Einsteins V2.4004:  
resonance adventure:  
300 trident machine

Ebb36 v1.2

# Initial belt shaper

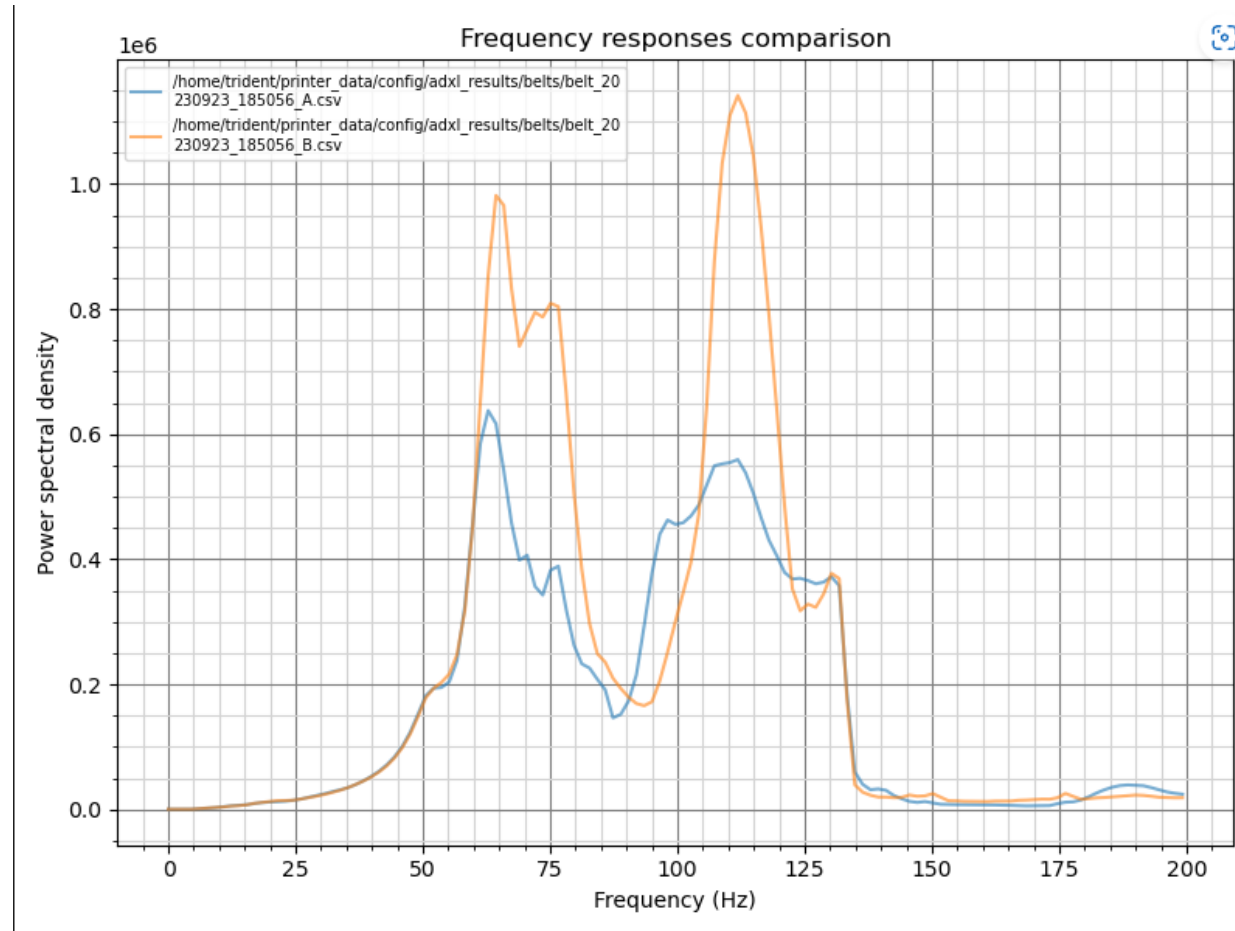
# Recommended securing canbus cable better

# The Attack Plan...

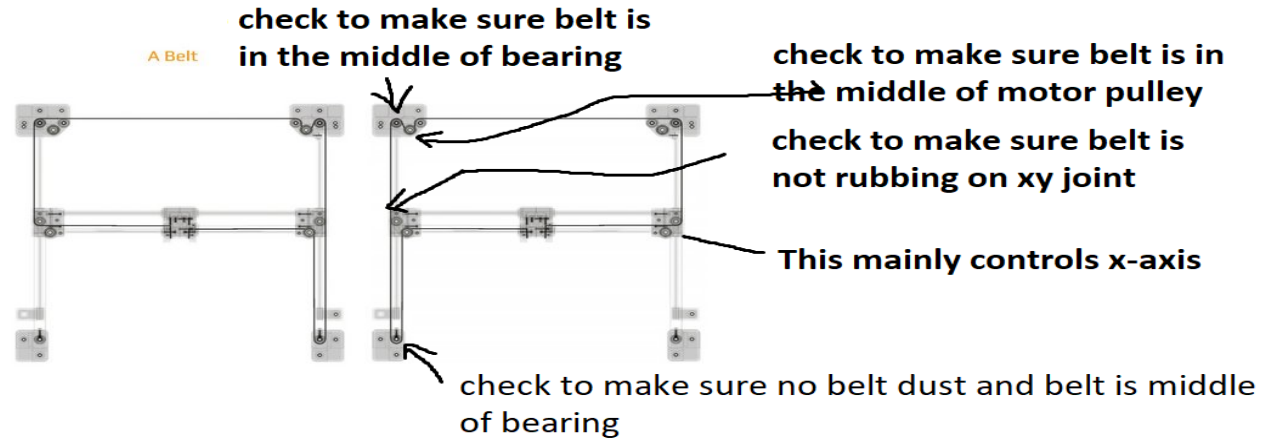
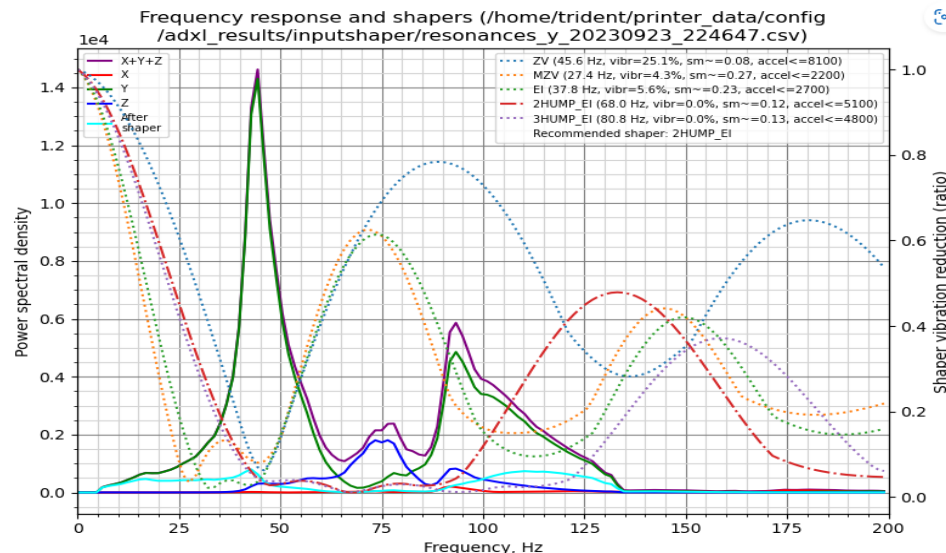
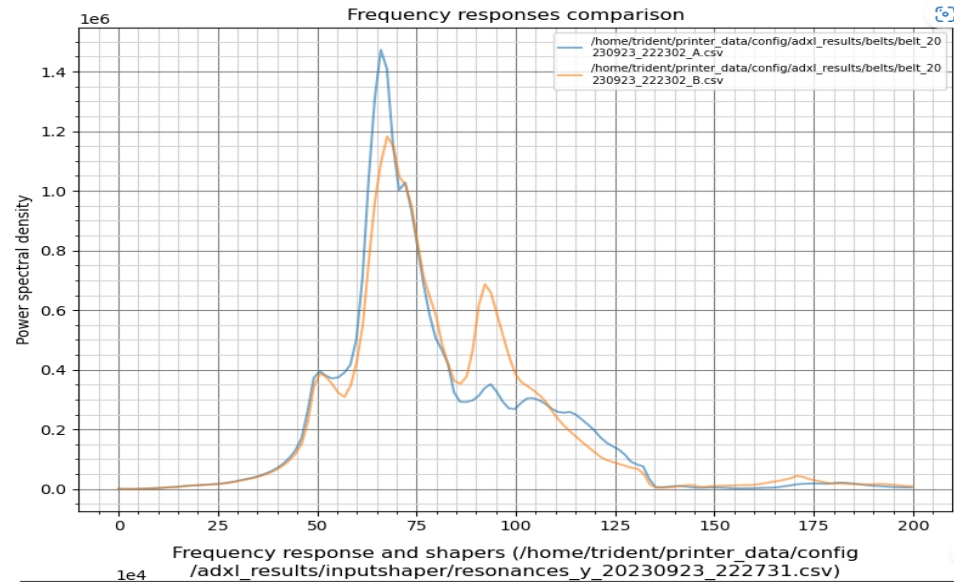
Comparing these two graphs we see that they have a common spike around 100Hz. In the belt shaper it is on the B belt. Above is a picture of the belt paths.

Based upon the data from this y-graph,

I think something in your b-belt path is the cause. What I would do is take the panels off and run a speed test. Watch the B-belt move and see what happens. I would also be listening to the y-linear rails and see if they sound good.

# What I found...

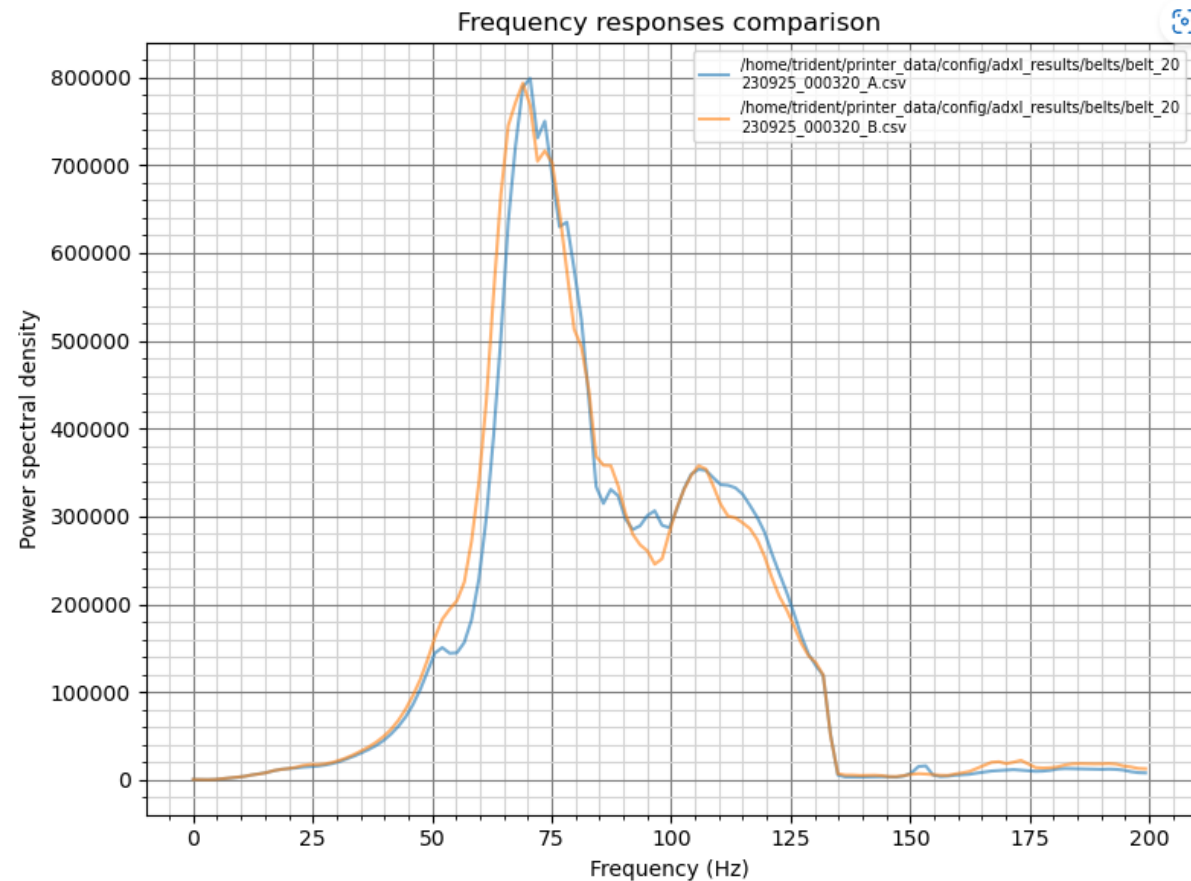
- When assembling the CNC XY Joints I put together the bearings in the same Stack configuration as a stock XY joint.  
This was incorrect and ended up with 1 additional 1mm washer in one of the bearing stacks.  
This caused the joint to not properly fit together and put a lot of additional pressure on the bearing pins.
- Disassembled the gantry and Fixed Bearing stacks (1 on each side)
- De-racked the gantry
- Reassembled remaining Gantry components and ran motion test
- Re-tensioned belts to between 108hz and 110hz
- Adjusted belt using Belt Shaper to get the following result

# Thoughts on xy joint belt shaper graph

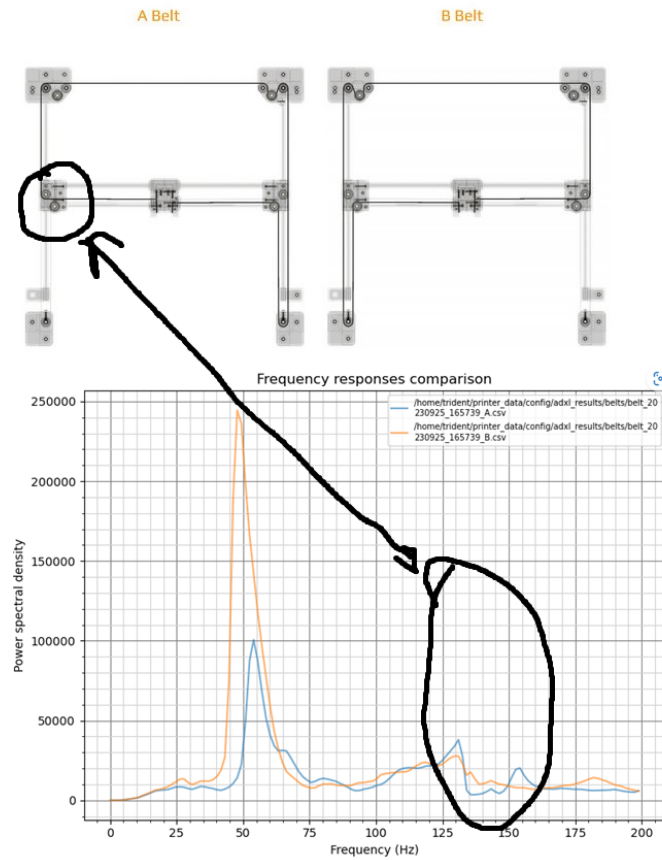
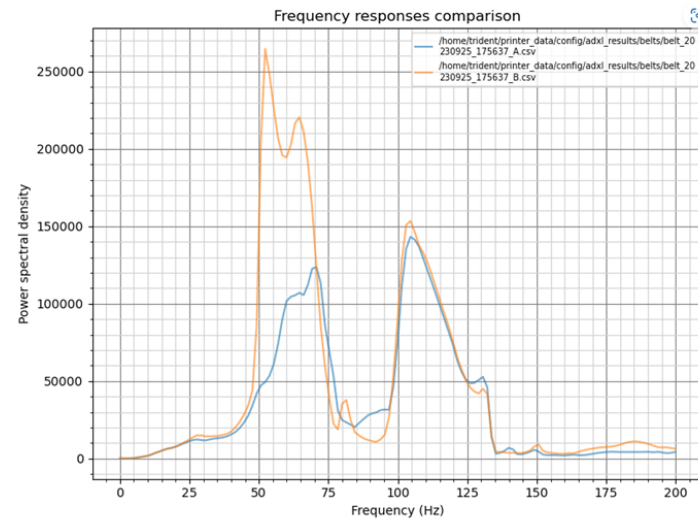
missing second hump

where does this lead us in troubleshooting. What information can be gleam?

Is it the bearings that are bad? Is it the 20tooth idler? Is the extrusion level? Is the linear rail good? Does the linear rail need more lube?

# Vitalii tap

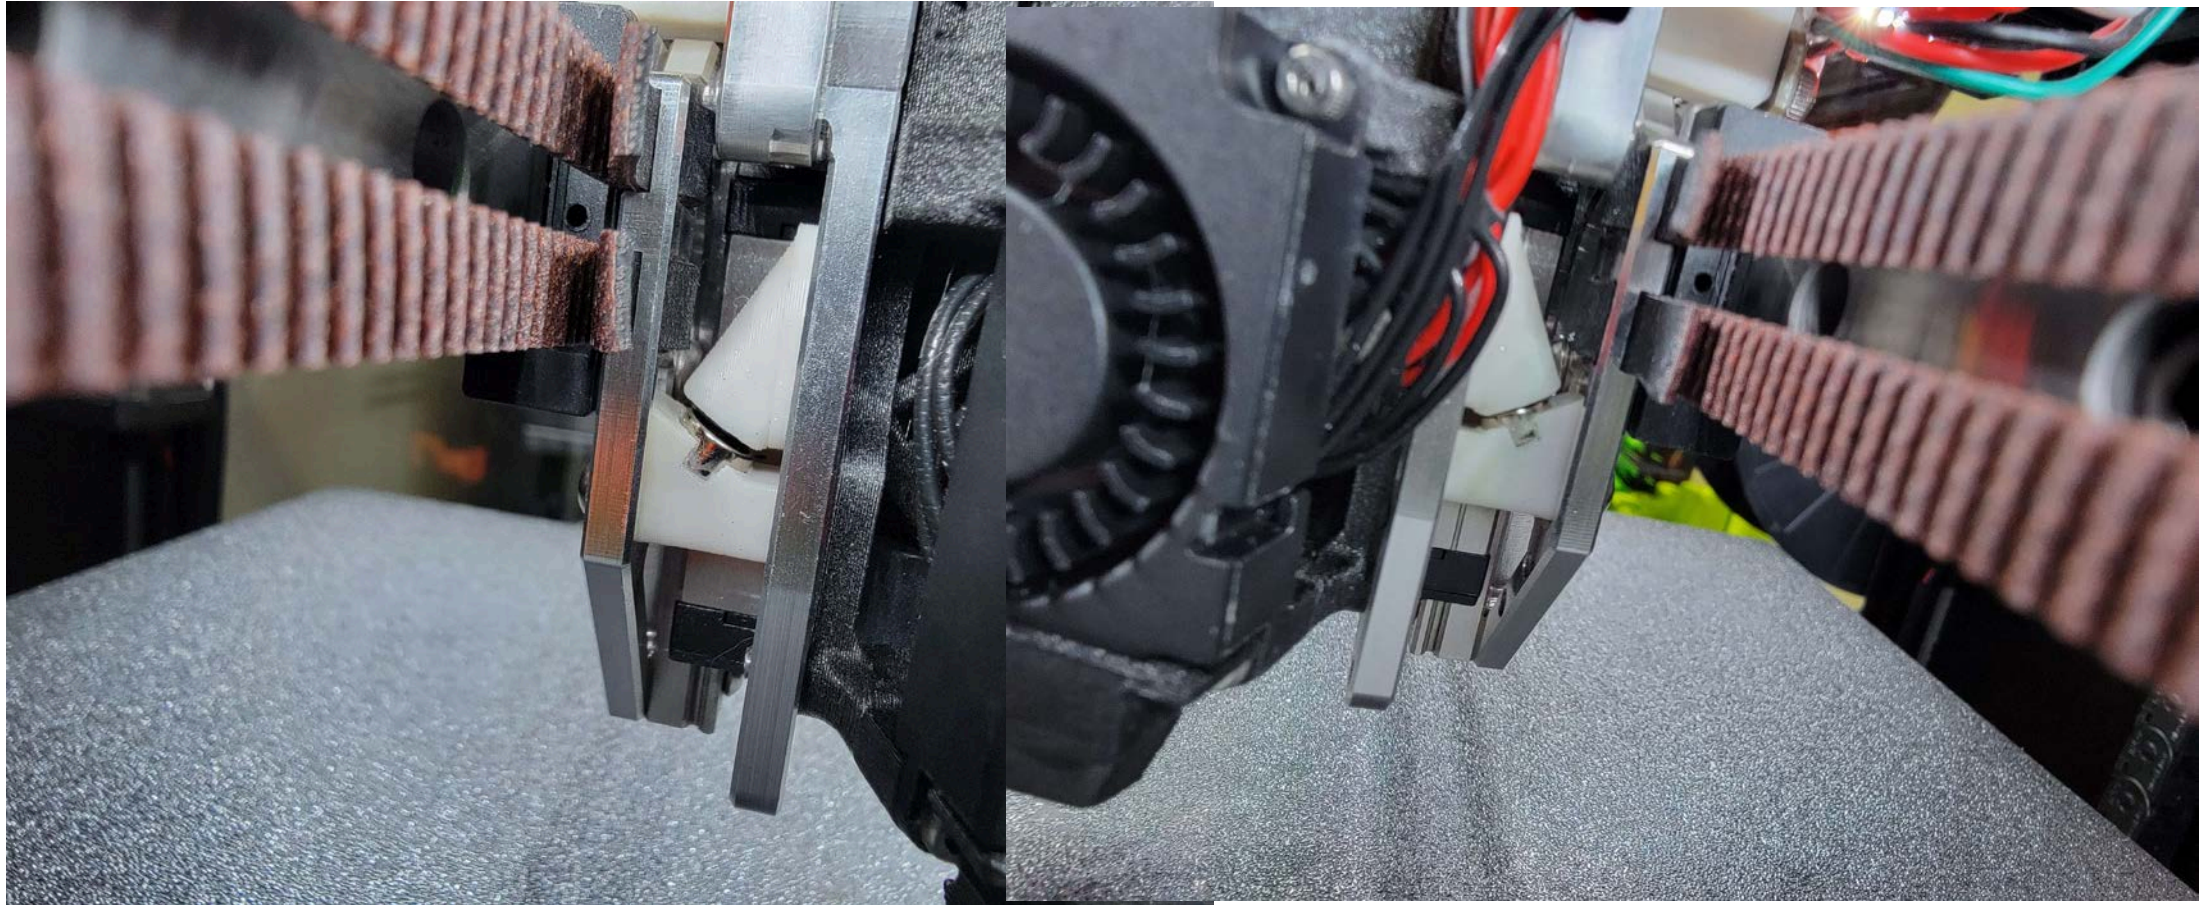
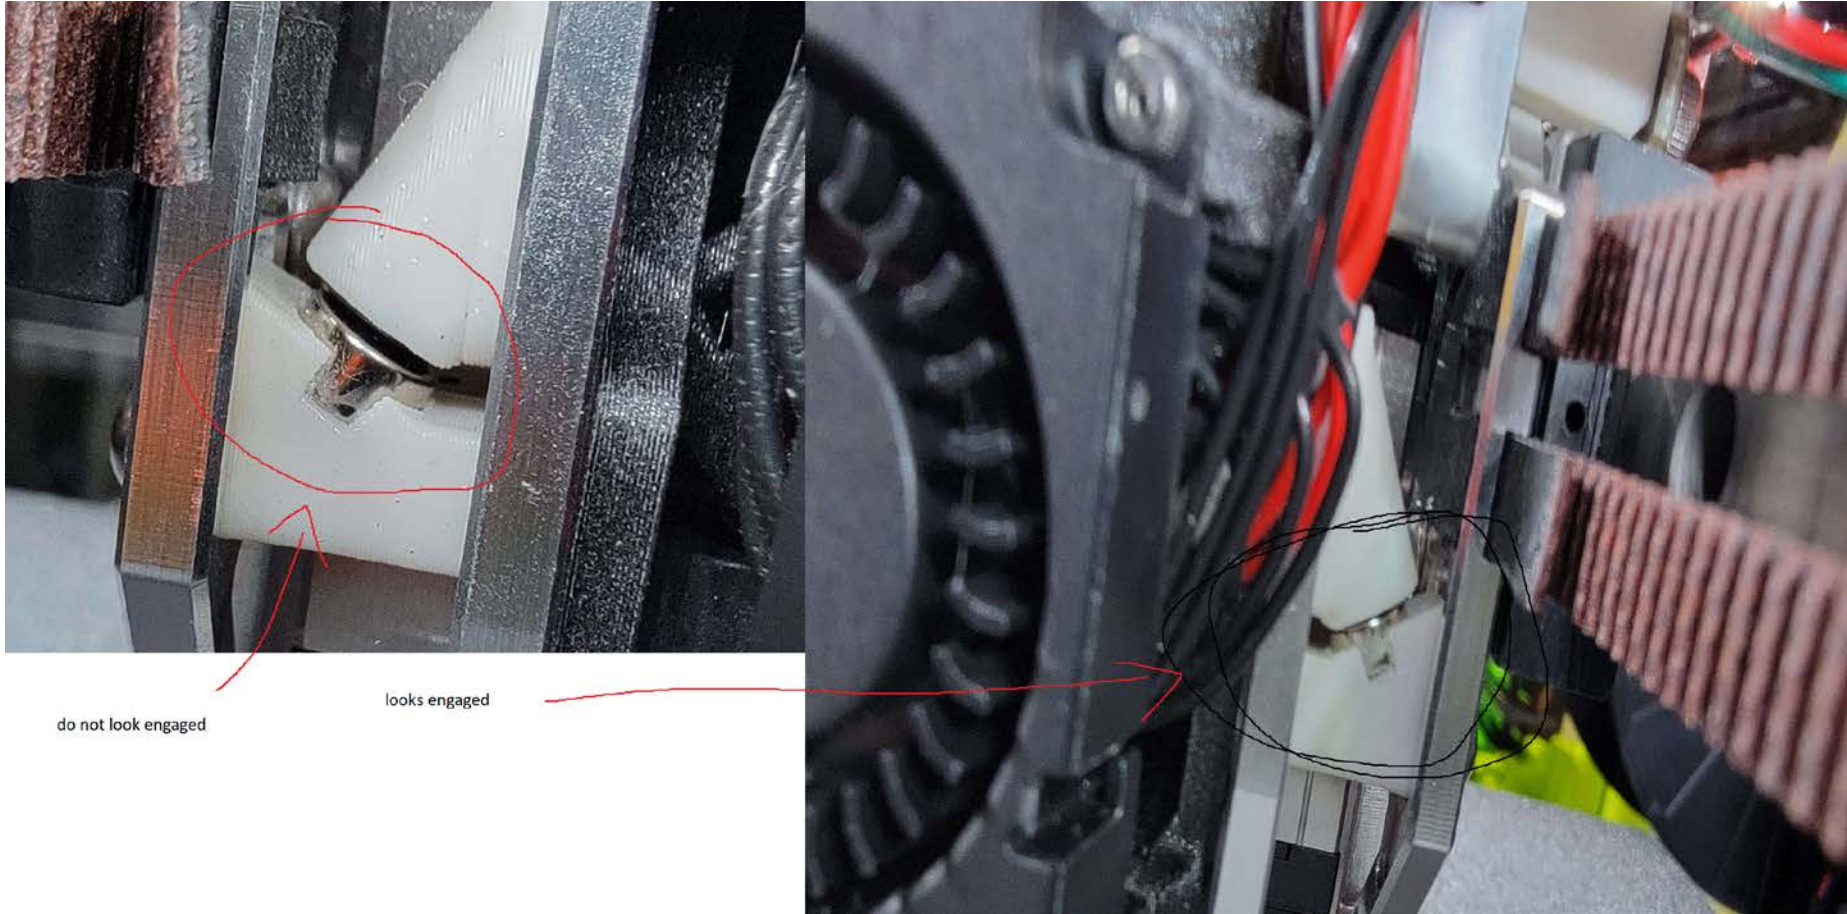
Recommendation adjust magnet on left side of printer for vitalii tap

# Magnet on Vitalii tap not properly engaged

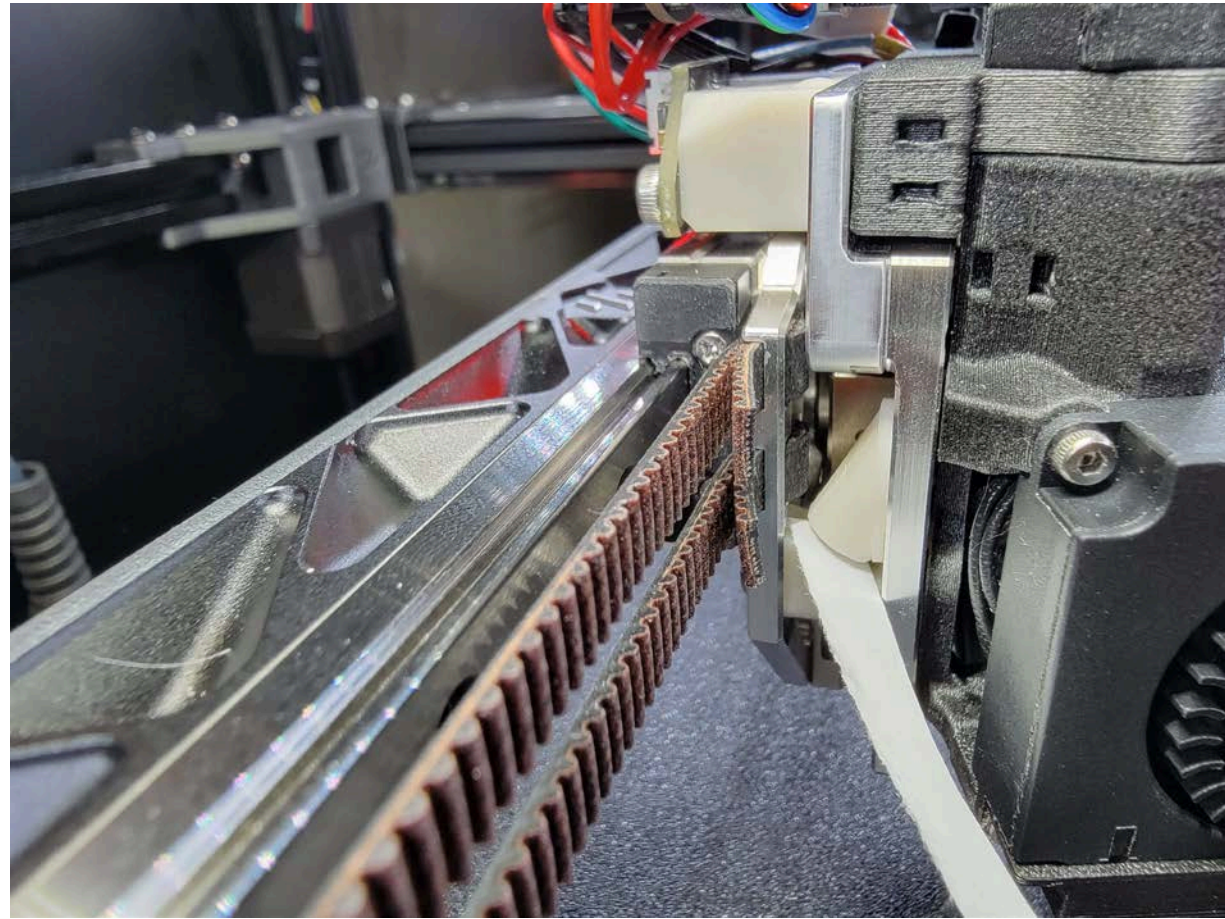
- Einstein states he can put the paper in as the right side of the left magnet only catches on the edge.
- Asked if he could rotate the magnet at all to make it flush
- If he cannot, for testing purposes only, I will ask if he can insert other magnets into the spot so hopefully that will fill the spot

# Possible issue with Vitalii tap

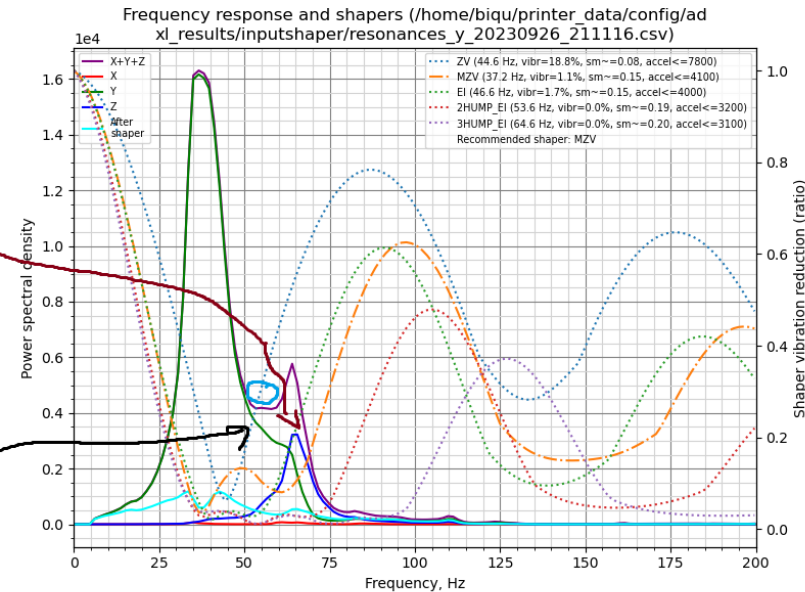
We see very similar graph the graphs are not the same, but we see that Y makes a peak and then trails off, followed by a z spike

What appears to be different is the blue circled area - the spacing between the y spike and the z spike

however, this may be caused by the same thing. I am receiving a vitalii tap this week I will investigate this
